ANDY'S FROZEN CUSTARD
PARKER, COLORADO

Title:
PROPOSED REVIEW BOARD ELEVATIONS

Sheet Number:
R002

2
R002
BUILDING ELEVATION - SOUTH E. 20TH AVE.
1/4" = 1'-0"

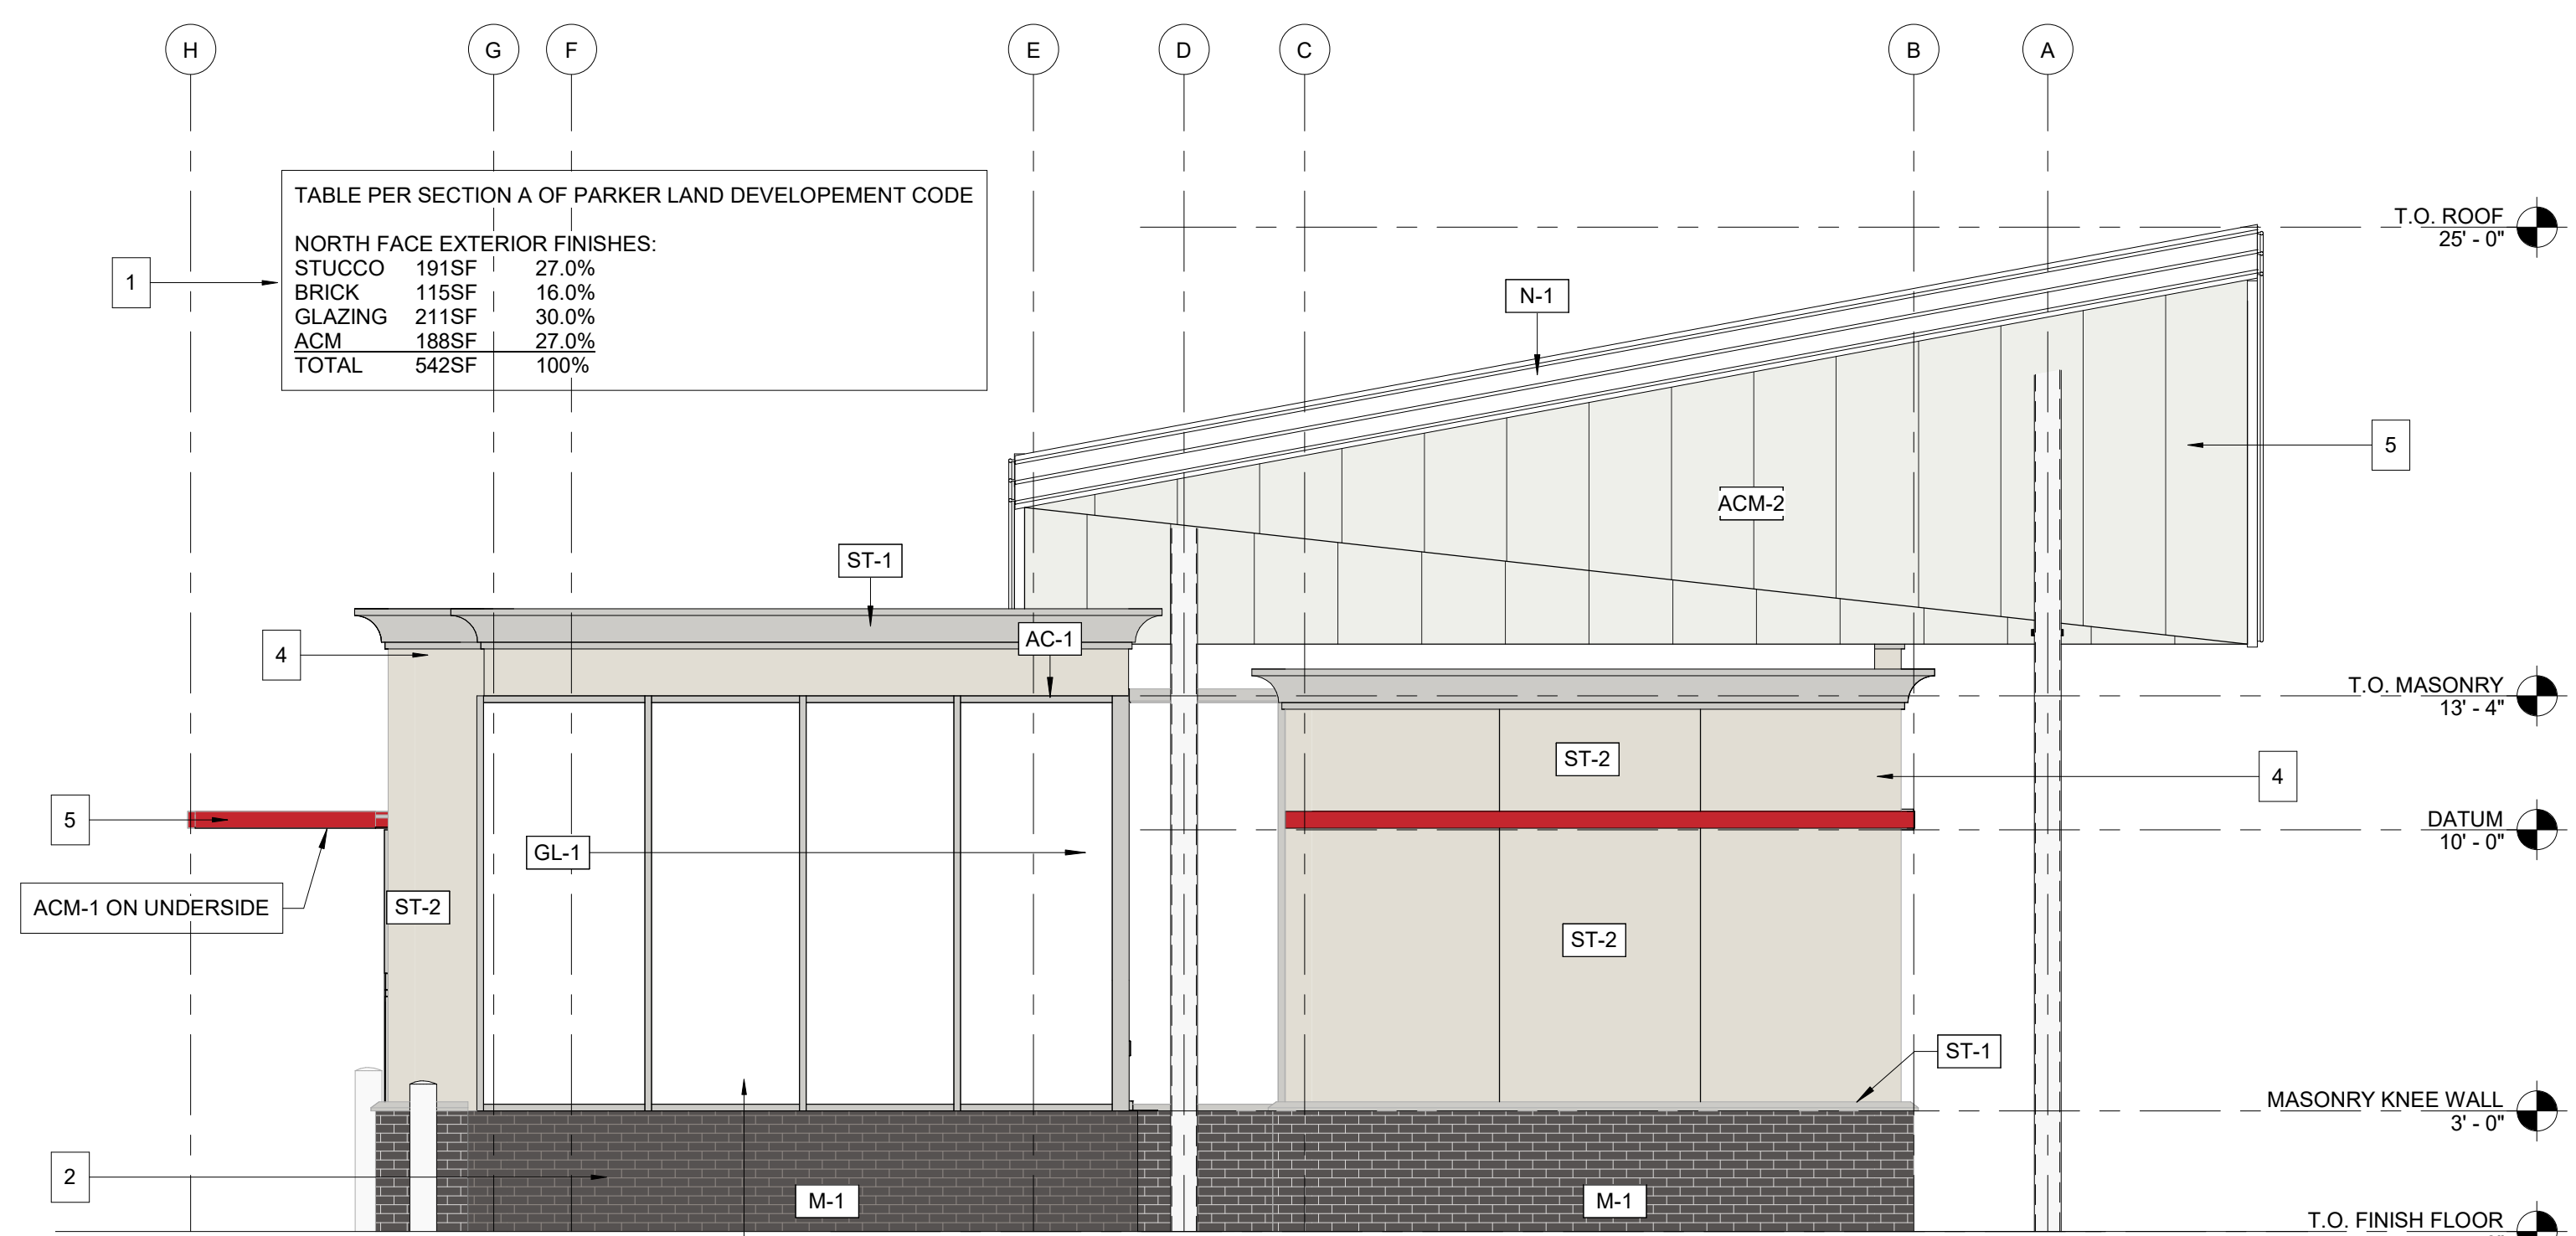
Elevation description is unclear, please discuss with planning for proper labeling. North Elevation or Elevation facing South or Front elevation?

1
R002
BUILDING ELEVATION - EAST FACE
1/4" = 1'-0"

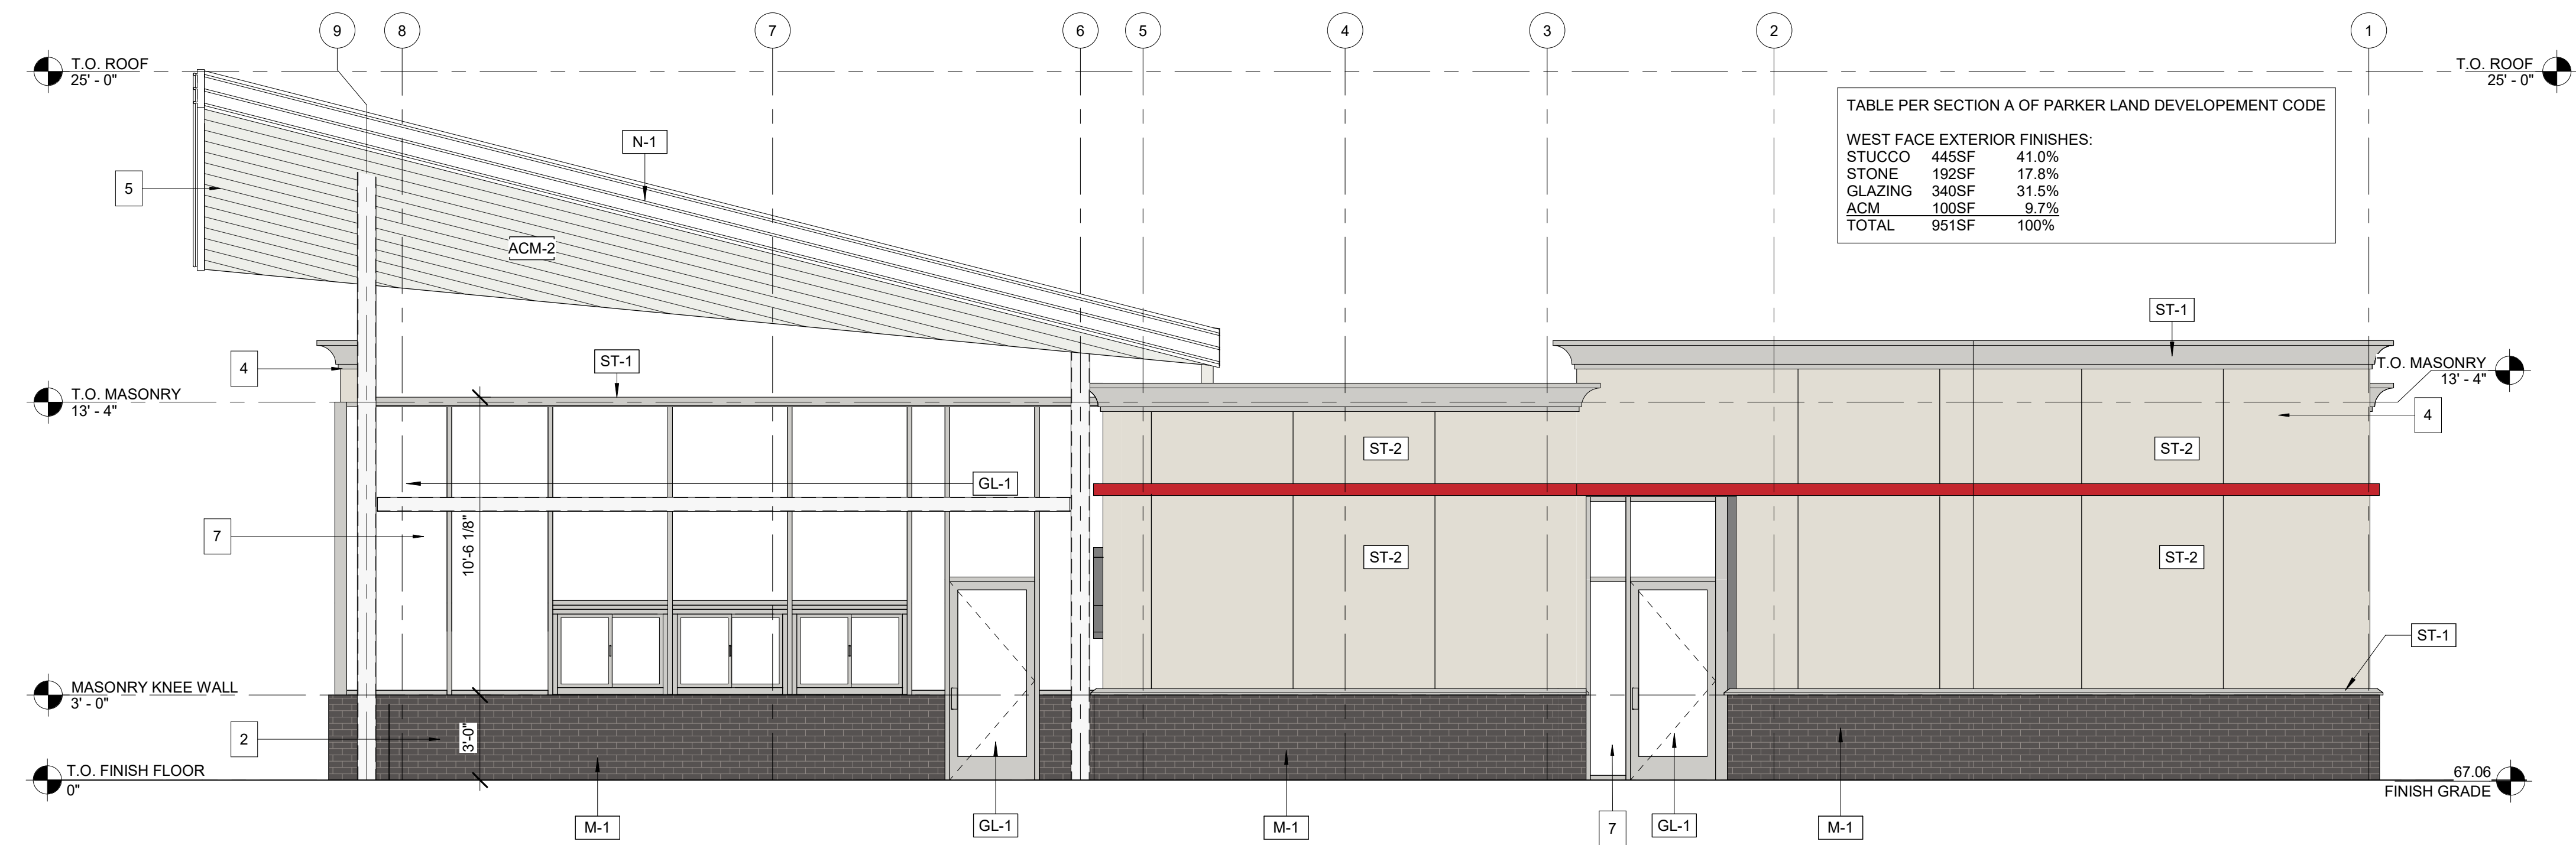
Elevation description is unclear, please discuss with planning for proper labeling. West Elevation or Elevation facing East?

2 BUILDING ELEVATION - FACING NORTH (REAR ELEVATION)
R003 1/4" = 1'-0"

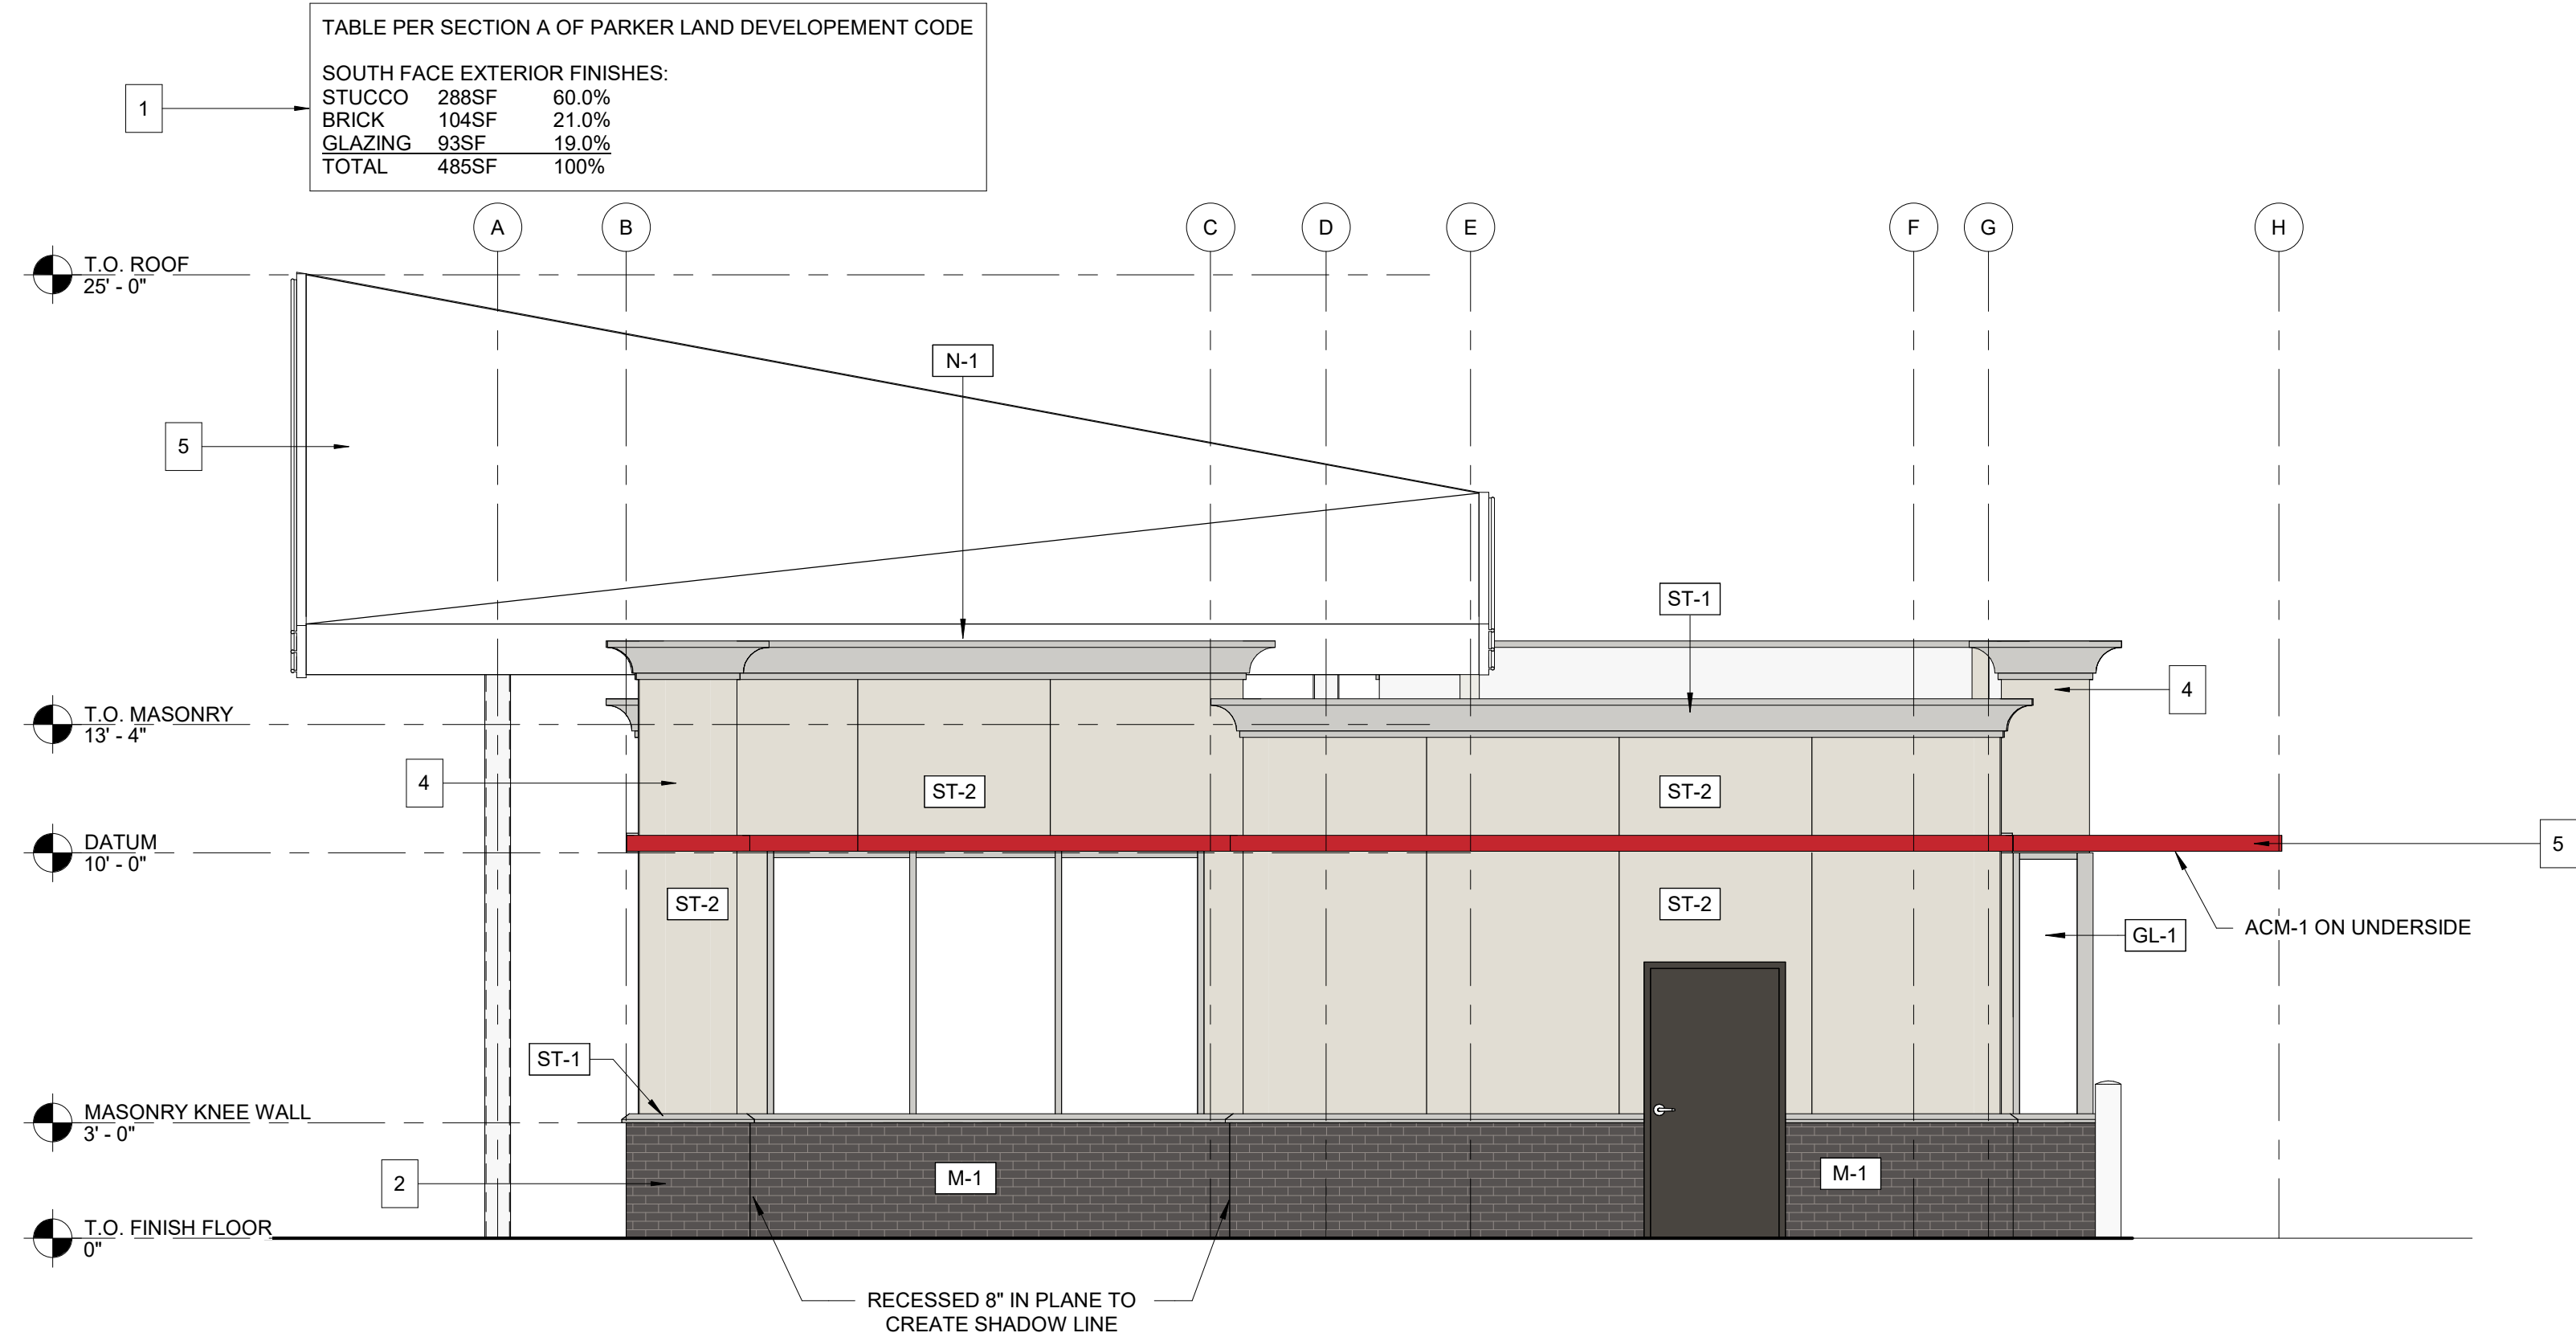
Elevation description is unclear, please discuss with planning for proper labeling. South Elevation or what is listed below?

1 BUILDING ELEVATION - WEST FACE
R003 1/4" = 1'-0"

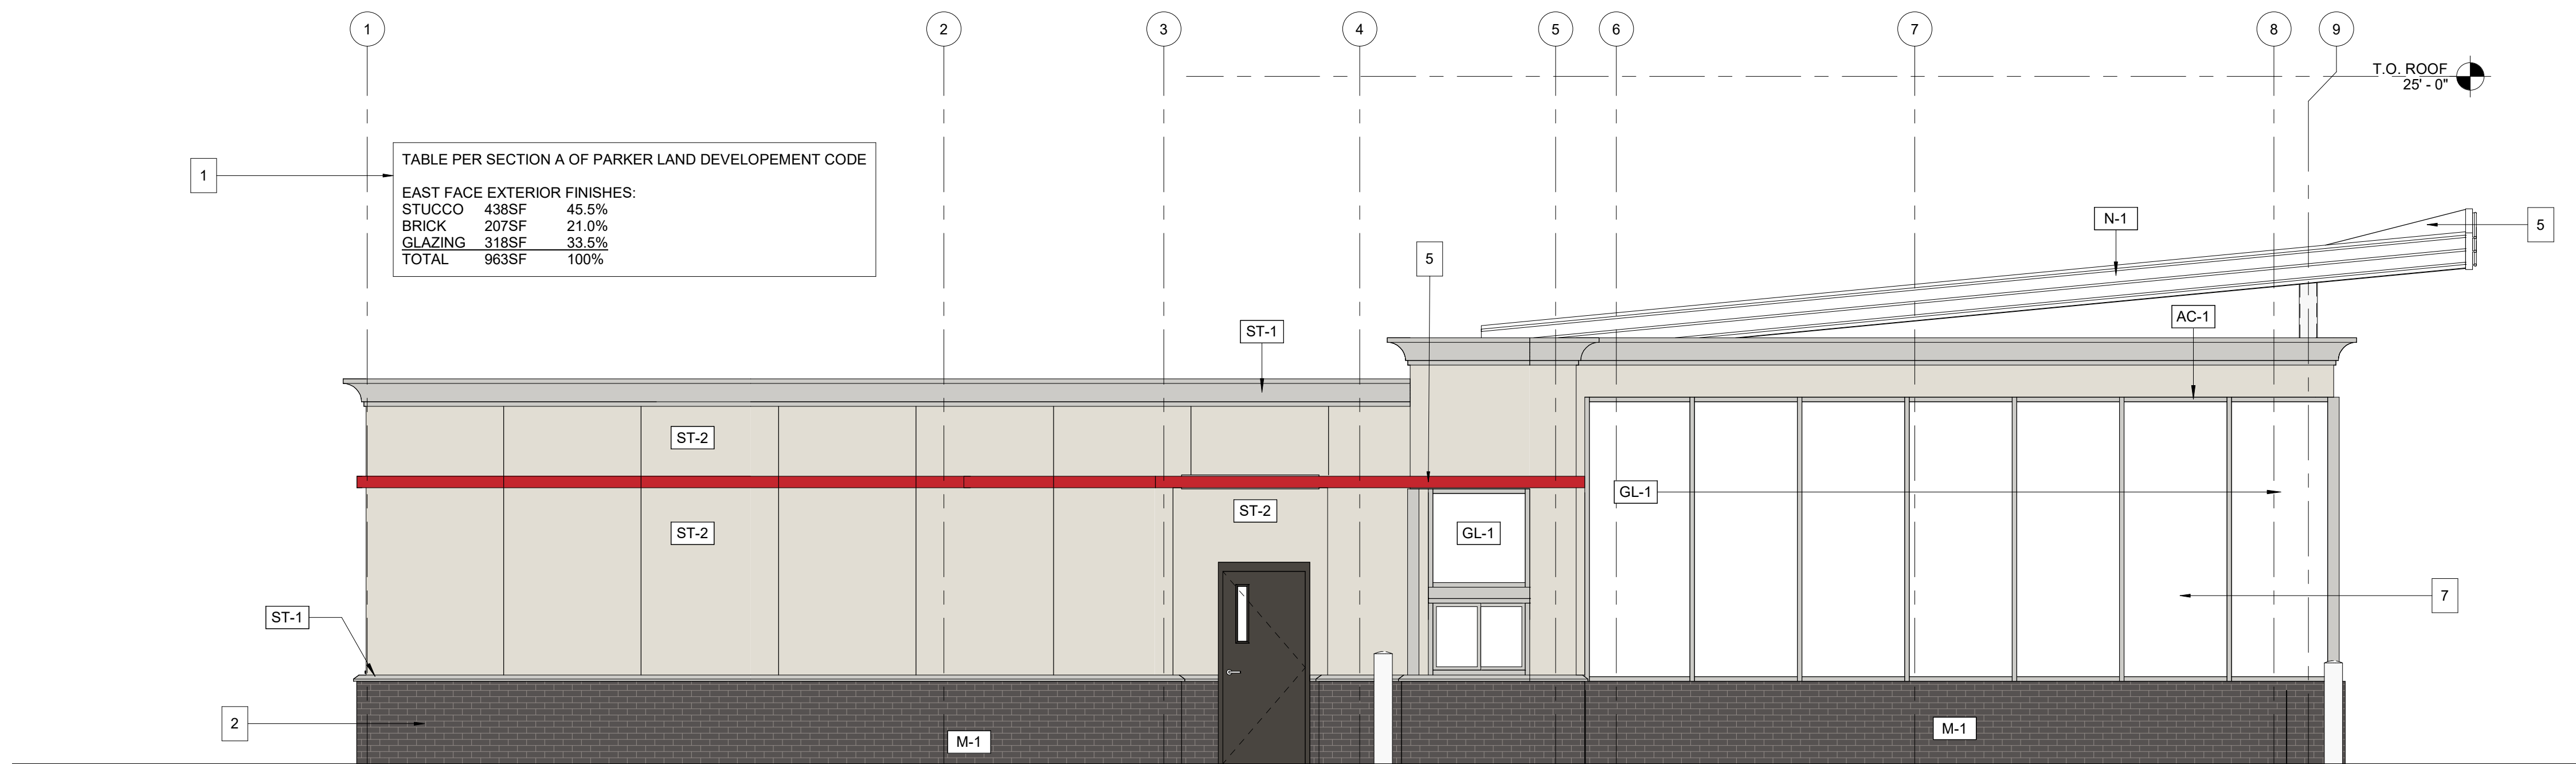
Elevation description is unclear, please discuss with planning for proper labeling. East Elevation or Elevation facing West?
